26 May 2023

Auckland Shooting Club C/- Terra Group 79 Grafton Road Auckland 1010

Geotechnical Addendum - 287 Tuhirangi Road, Makarau, Auckland (Our Reference: 13704.001.001_03)

The scope of this assessment is limited to a review of the updated development plans (by Terra Consultants Ltd, project number: 230400, rev: A, dated 13 March 2023) and is focussed on the accessway, parking area, and five shooting bays within the central part of the site. This letter summarises the findings of our desktop assessment.

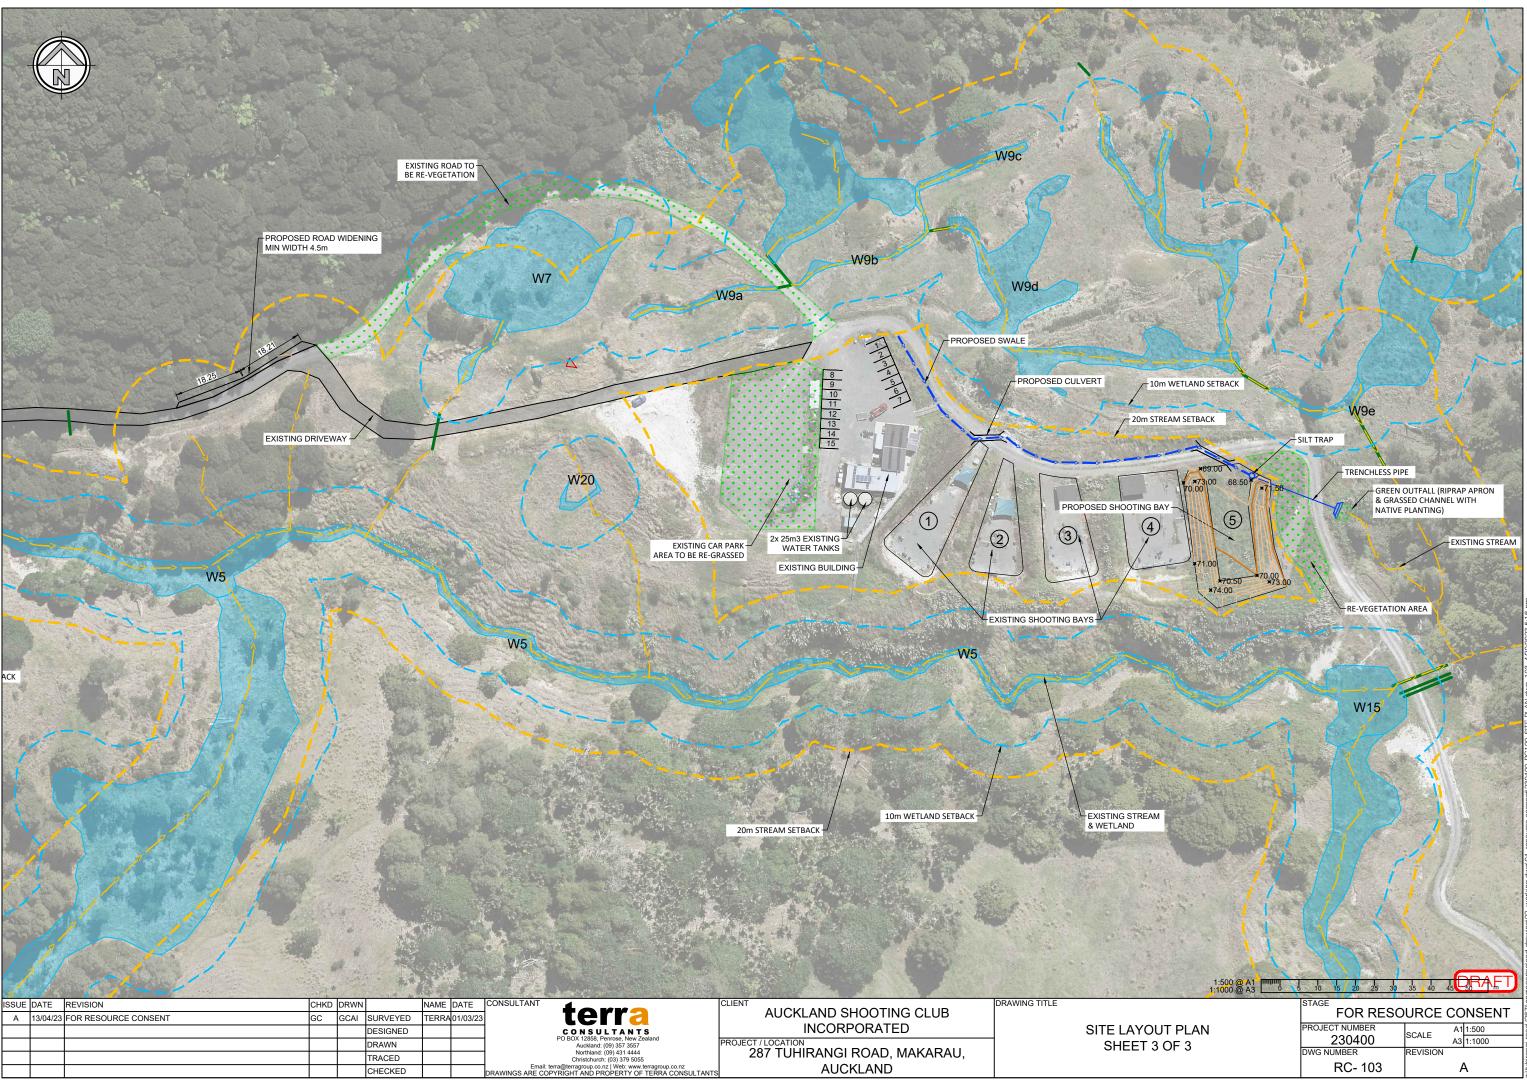
A site layout plan prepared by Terra Consultants (drawing number RC-103; dated 1 March 2023), copy attached, indicates that future proposed works include:

- Construction of a passing bay and proposed widening of the access road. These works will be carried out on the northern side of the driveway at the base of the northern slope and will be primarily in cut. The passing bay will be minimum 5.5 m width and 5.0 m long, the road widening will be minimum 4.5 m width and 36.5 m long.

- Proposed cut and fills of up to 2.1 m and 4.1 m respectively above existing ground levels. Maximum extent of fills are shown to be located in the southeast portion and maximum cuts are shown to be in the southwest portion of Bay 5.

- The construction of a new shooting bay (Bay 5) to replace the western-most existing shooting bay, as well as associated drainage works. The drainage works are understood to comprise a swale along the north of the existing shooting bays with two culverts proposed to along the existing access way. A green outfall with a riprap apron is proposed to the east of Bay 5 discharging into the existing stream.

• The construction of Shooting Bay 5 will include three earth bunds (along the western, eastern and southern sides of the shooting bay) proposed to be formed at approximately 45 to 60 degrees to the horizontal and up to 3 m high.

We recommend earthworks associated with Shooting Bay 5 be observed and tested by a suitably qualified geotechnical professional to a minimum of CM3 level.

As the proposed driveway widening and passing bay are located in an area of potential instability (and cuts are proposed which may de-buttress the northern slope), we recommend that further geotechnical investigation and slope stability analysis is completed in these areas to assess the suitability of the proposed works and provide associated geotechnical recommendations to achieve the desired outcome without increasing the chance of instability in the area.
